# UNITED STATES PATENT AND TRADEMARK OFFICE

APPLICATION NO.	FILING DATE	FIRST NAMED INVENTOR	ATTORNEY DOCKET NO.	CONFIRMATION NO.
10/598,969	08/01/2007	Robert Charles Sutton	1281-173PUS (F-30037US)	2719
70757	7590	11/07/2011	EXAMINER	
Christopher & Weisberg, P.A. 200 East Las Olas Boulevard Suite 2040 Fort Lauderdale, FL 33301			LEE, SI	
			ART UNIT	PAPER NUMBER
			3771	
			MAIL DATE	DELIVERY MODE
			11/07/2011	PAPER

<b>Office Action Summary</b>	<b>Application No.</b> 10/598,969	<b>Applicant(s)</b> SUTTON ET AL.	
	<b>Examiner</b> SI LEE	<b>Art Unit</b> 3771

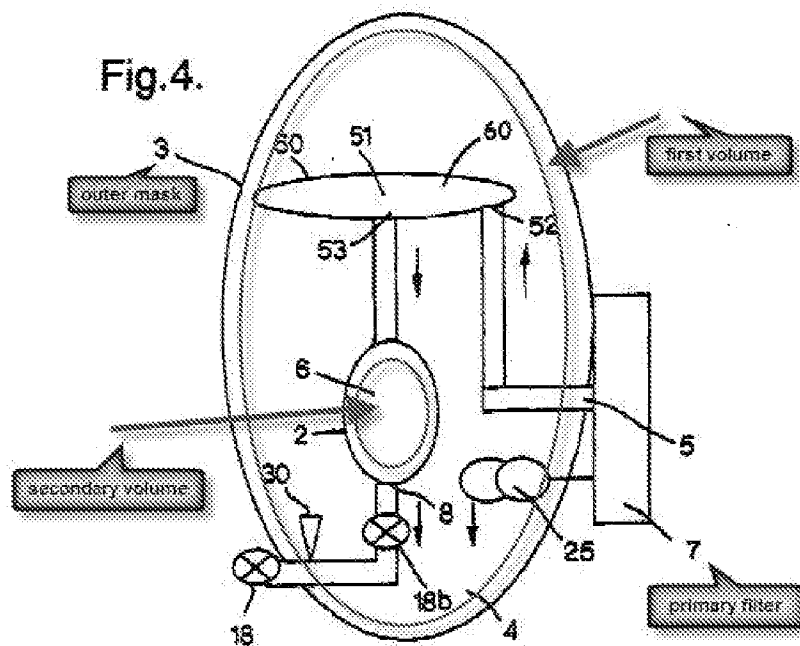
Regarding claim 1, figure 4 of Richardson discloses a respirator that covers a face of the wearer (column 3 lines 48-51) and incorporating a visor (50 - ocular mask). Figure 4 of Richardson shows a primary filter (7 - filter canister). Examiner regards Richardson discloses a primary volume (the volume excluding the secondary volume) where air can be drawn from the exterior (column 7 lines 25-26) via the primary filter (7). Examiner regards there is a secondary volume positioned to enclose the nose and mouth of the user (2 - oronasal mask) (see figure 4 below).

Richardson has a conduit connecting the visor (50) and the oronasal mask (2) but lacks a secondary filter to provide filter gas passing from the main volume to the secondary volume (see figure 4 below). However, figure 3 of Tayebi teaches a filter (17 - filter liner) can be provided to an oronasal mask (column 7 lines 31-35 and Abstract lines 1-3). Figure 3 of Tayebi shows that the filter liner (17) is provided prior to the air entering the oronasal mask to filter breathed air (Abstract lines 11-14). Therefore, it would have been obvious to one of ordinary skill in the art at the time the invention was made to provide Richardson's conduit with a filter liner as taught by Tayebi, since such a modification would provide purified air before the user inhales the air.

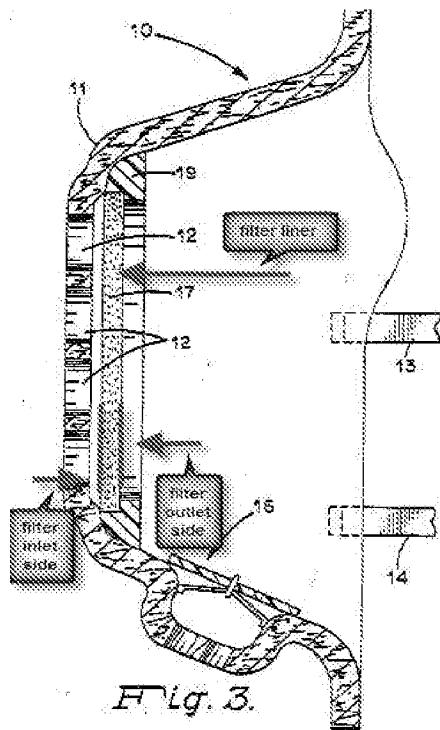
Regarding claim 2, the modified Richardson has the secondary filter (17 of Tayebi) filtering air traveling around a portion of the second volume, the secondary filter having a filter inlet for receiving air and a filter outlet for outputting air (see figure 3 of Tayebi below).

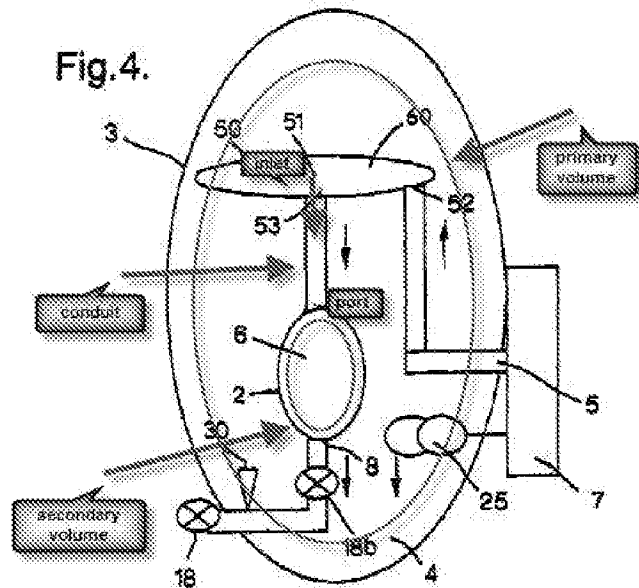
Regarding claim 8, the modified Richardson has a secondary inlet (see figure 4 of Richardson below) allowing air to travel from the first volume to the secondary filter (17 of Tayebi).

Regarding claim 9, figure 4 of Richardson has a secondary port on the oronasal mask (2), a conduit having a first portion including the secondary inlet and a second portion coupled to the secondary port (see figure 4 above).

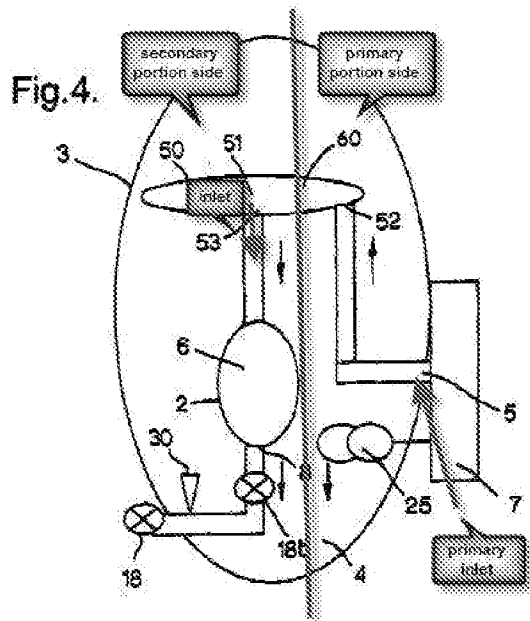
Regarding claim 10, examiner regards figure 4 of Richardson below shows the first volume having a primary portion and a secondary portion where the primary portion is located on a different side of the oronasal mask (2) than the secondary portion, the secondary inlet being positioned within a secondary portion and distal the primary inlet

port, and the primary inlet port (5) being positioned proximate the primary portion.
